To: Nick Sugar, City Planner and Amanda Krickovich, Community Development, City of Hudson
From: Olivia Zepp, AIA | Historic Architecture, Perspectus
Date: October 19, 2023
Re: 201 N. Main Street
CC: Lauren Pinney Burge, AIA, Principal & Alice Sloan, Assoc. AIA, APT-RP | Historic Architecture, Perspectus

SUBJECT PROPERTY: 201 N. Main Street

Image 3: 1916 Sanborn Map, Ohio Web Library. Note the configuration of the structure with a portion of the current rear (east) addition is existing by 1916. (North is up)

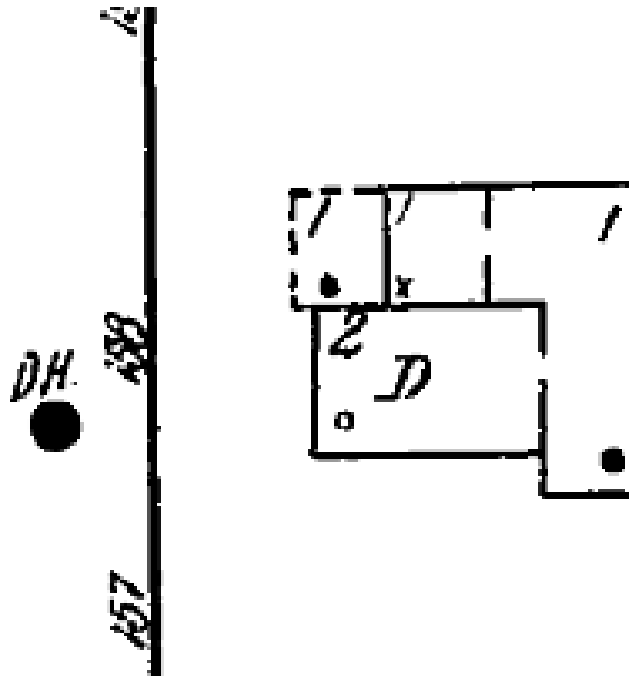
7. Demolition of the one-story rear additions, a portion of which appears in the 1916 Sanborn map (see Image 3). The additions appear to have been altered since their original construction.

Image 8: Rear (east) elevation. One-story rear addition to be removed, including presumed addition that existed by 1916 according to the Sanborn map in Image 3.
